MARKED-UP SPS EMERGENCY PLAN CHANGES

**VIRGINIA ELECTRIC AND POWER COMPANY
(DOMINION ENERGY VIRGINIA)
NORTH ANNA POWER STATION UNITS 1 AND 2
SURRY POWER STATION UNITS 1 AND 2**

Title: Surry Power Station Emergency Plan

Revision # TBD updates the entire document. Revised material includes, but is not limited to:

FIGURE 5.2

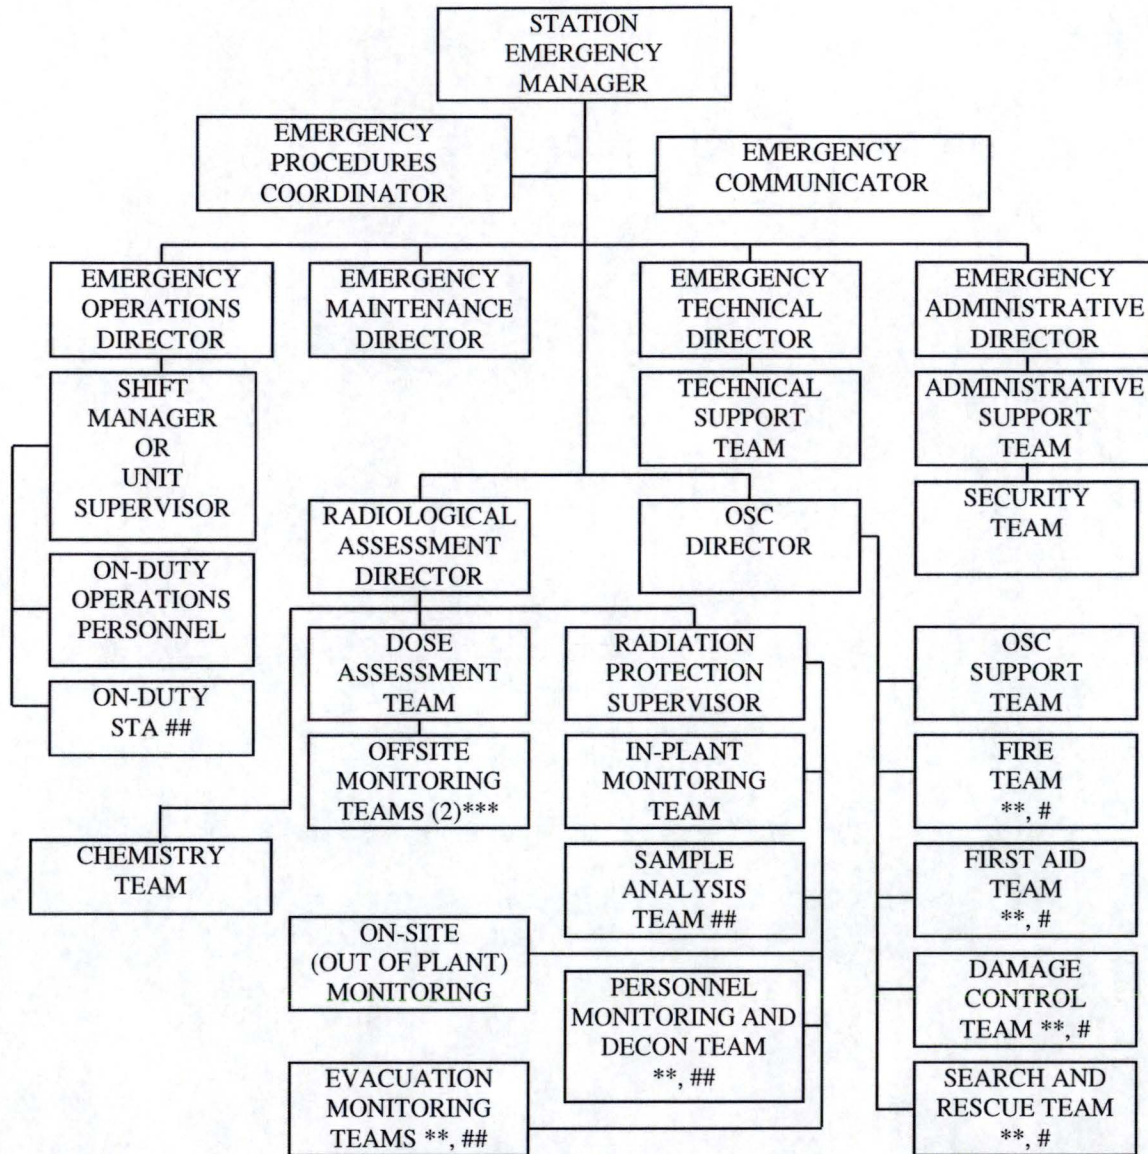
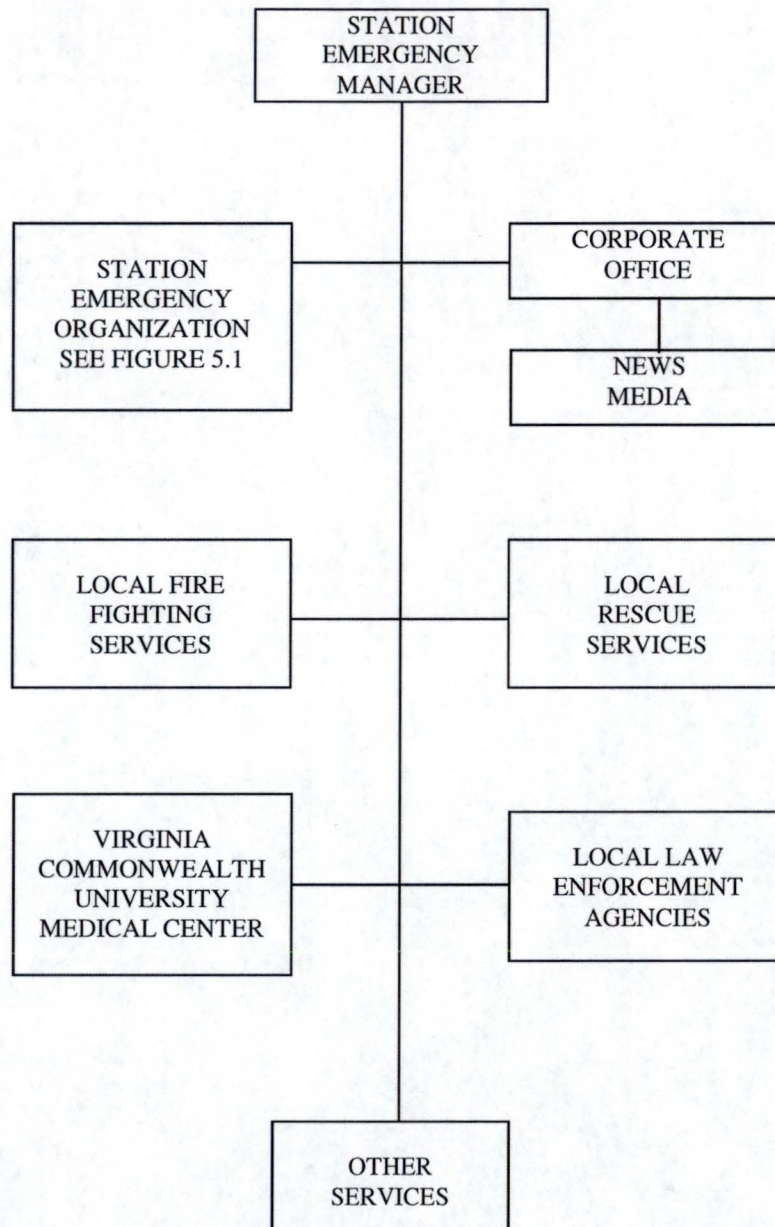
*** Transferred to LEOF-CERC when facility activated.

STATION TO SUPPORT GROUP INTERFACE
FOLLOWING LEOFCERC ACTIVATION
FIGURE 5.4

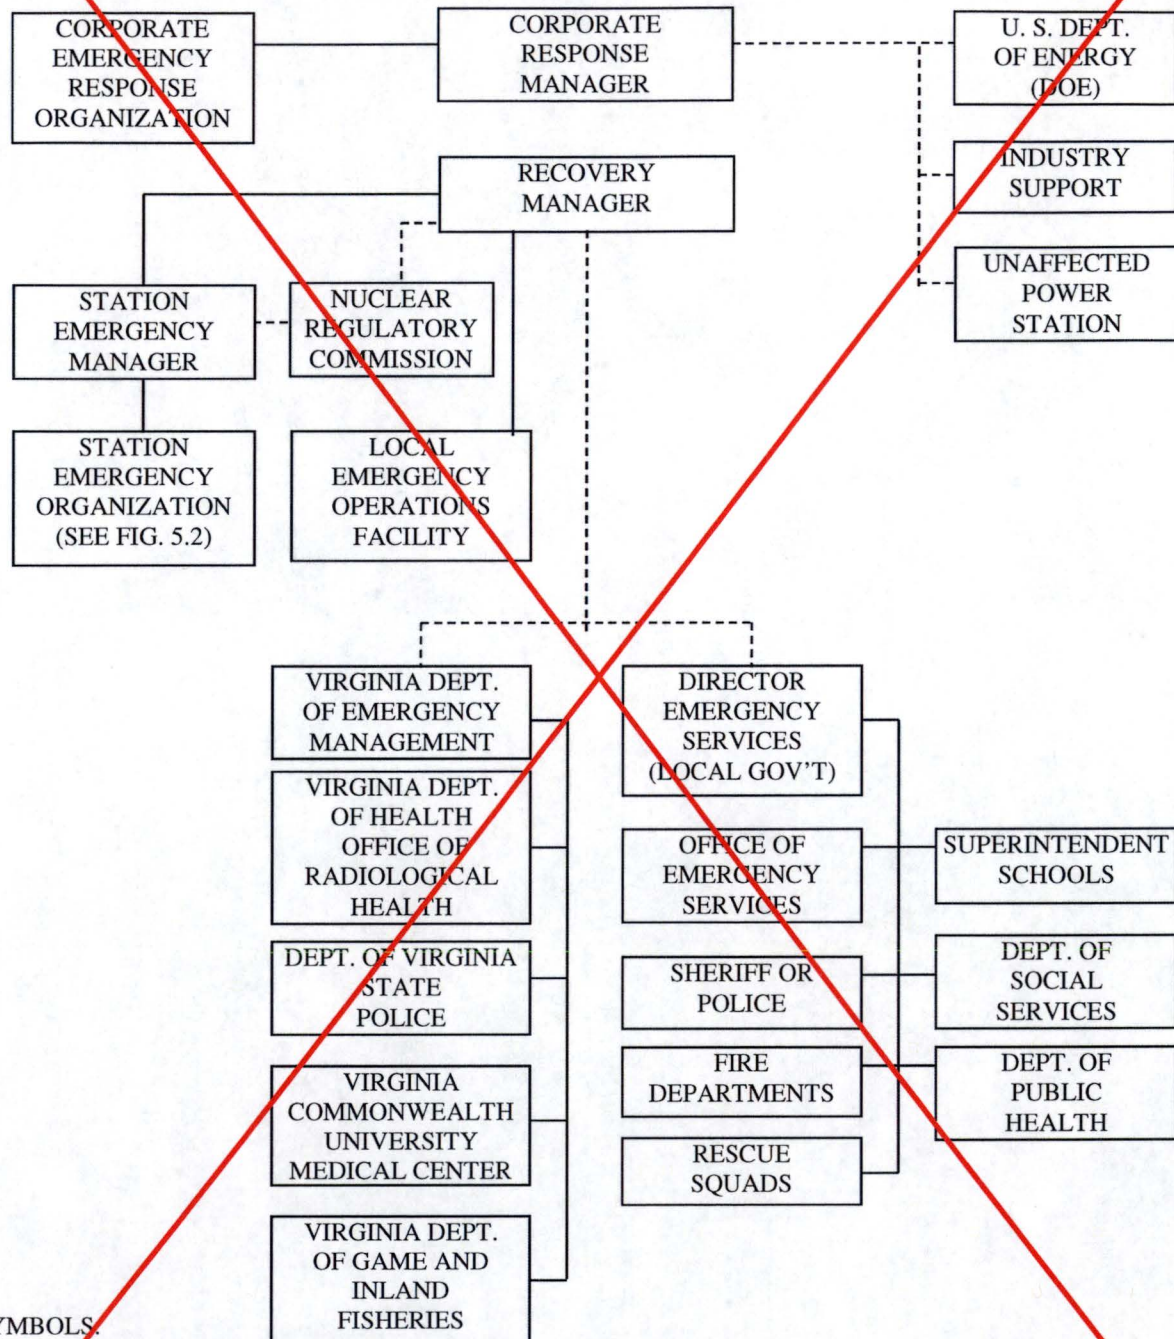
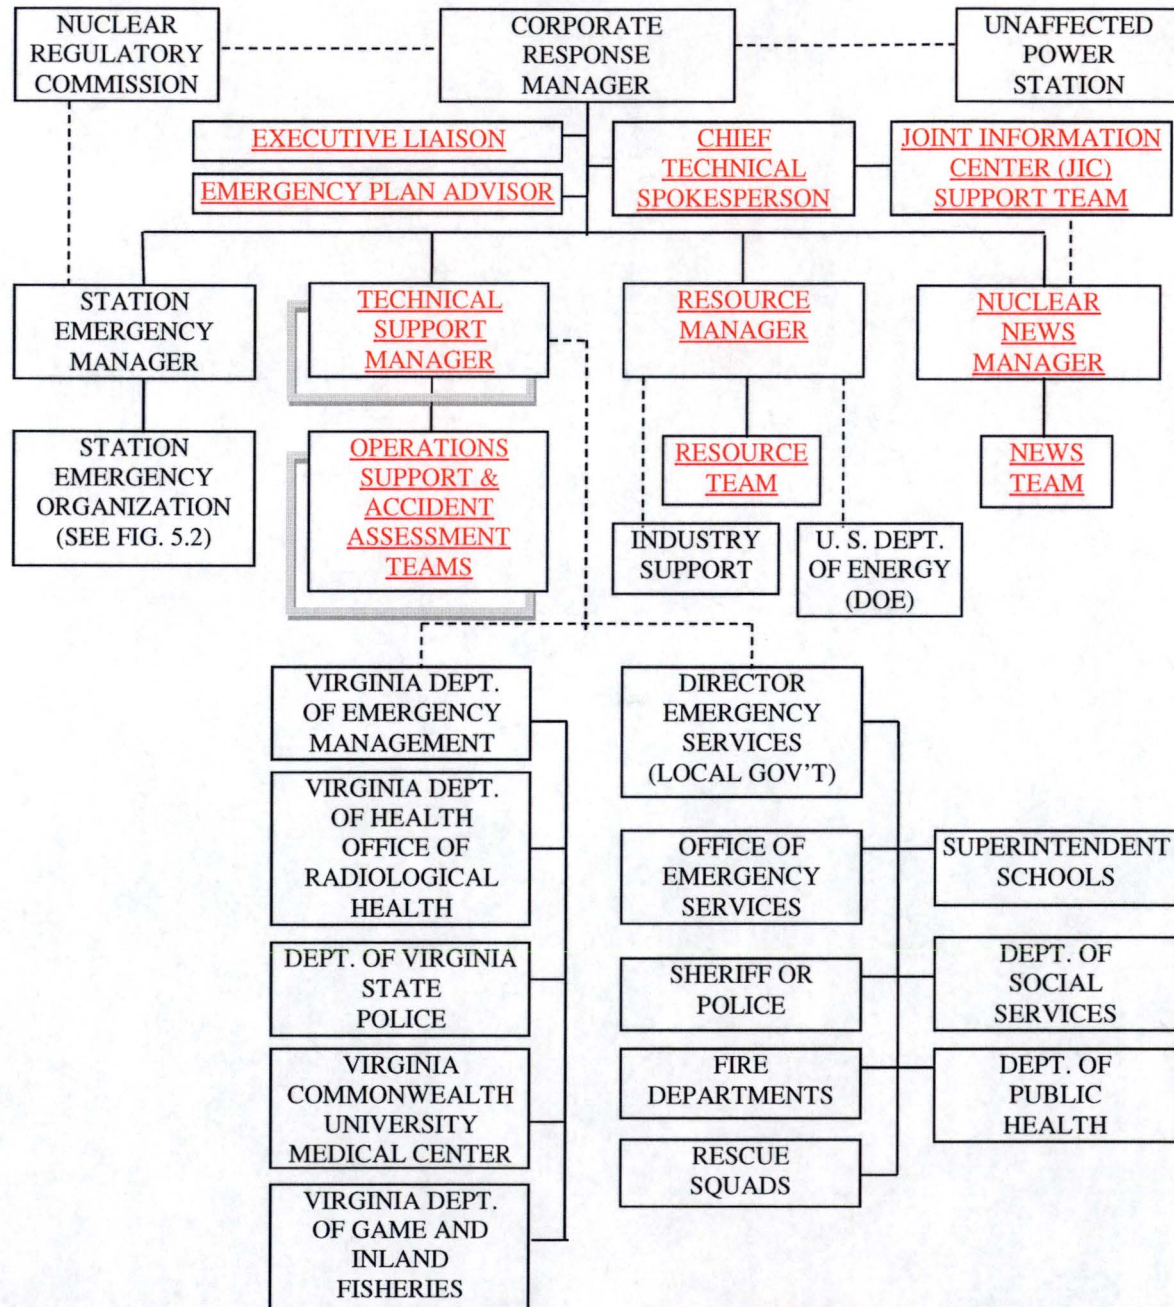
STATION TO SUPPORT GROUP INTERFACE
FOLLOWING LEOF ACTIVATION
FIGURE 5.4

COMMUNICATIONS LINKS
FIGURE 7.3

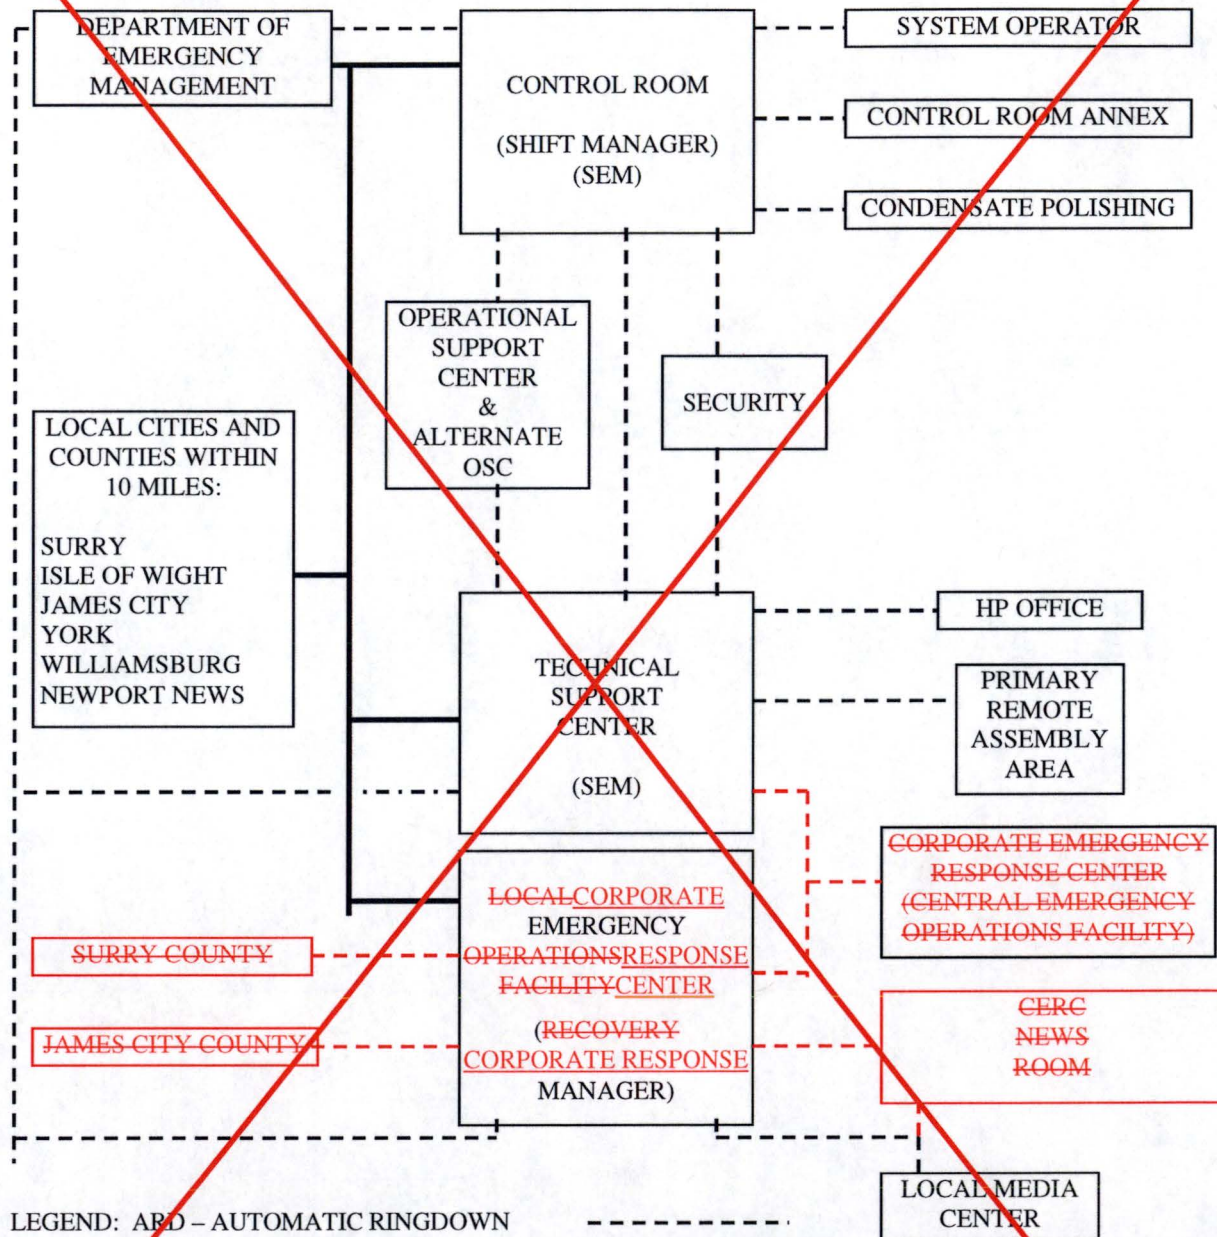
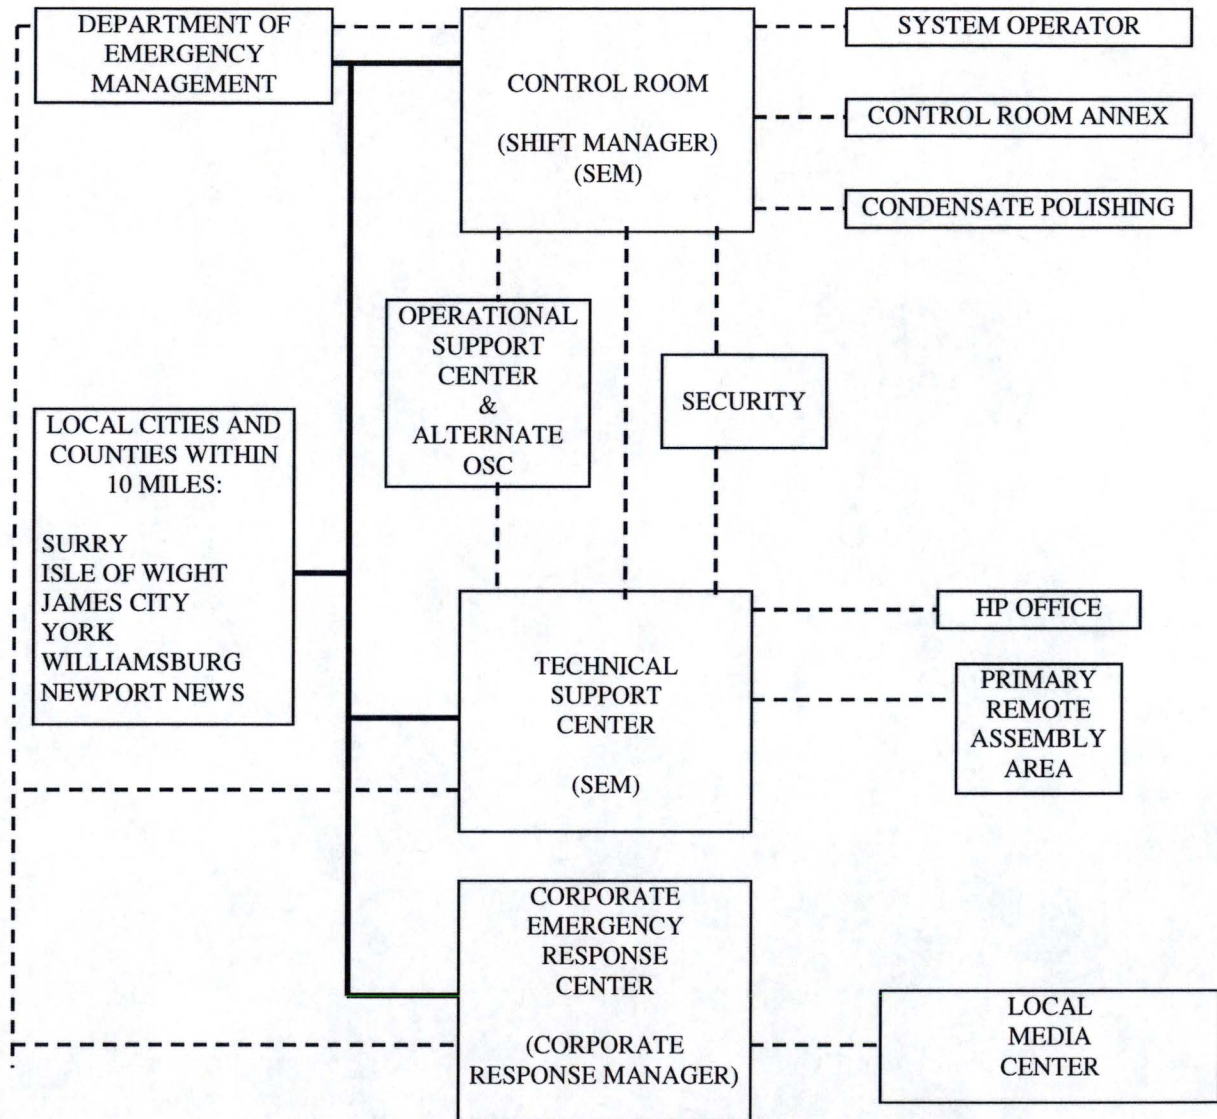
2. Incorporation of the applicable content previously contained in the Corporate Emergency Response Plan.
[ITEM PREVIOUSLY NUMBERED 3 REMOVED]
3. Elimination of automatic ringdown phones between the EOF and Surry County, and between the EOF and James City County.

FIGURE 9.1

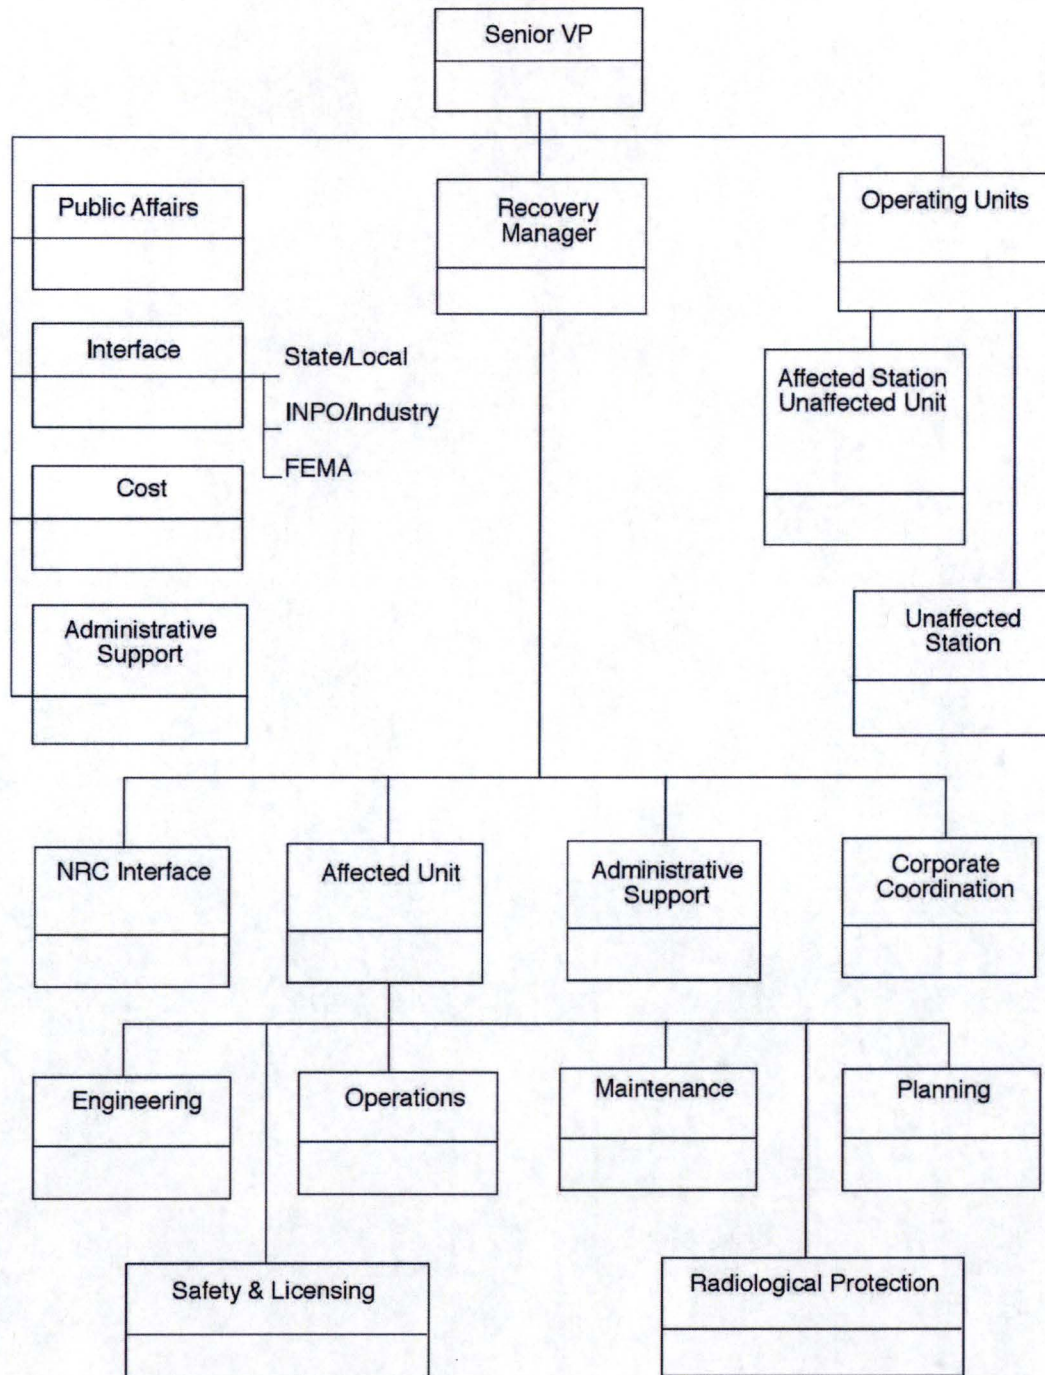
The recovery process will be managed by a special, designated organization composed of Dominion personnel. The recovery organization is described in ~~the Corporate Emergency Response Plan~~ Figure 9.1. The basic organization may be modified as required to address the needs of the given situation. The ~~Recovery-Technical Support~~ Manager assumes control and direction of the recovery operation with the authority and responsibilities for implementing and administering the recovery plan and organization set forth in the Corporate Emergency Response Plan. Responsibilities of the recovery organization include defining recovery objectives, developing a plan to accomplish these objectives, establishing controls and anticipating potential complications, monitoring the recovery effort and adjusting the plan accordingly, and evaluating accomplishments against the designated objectives.
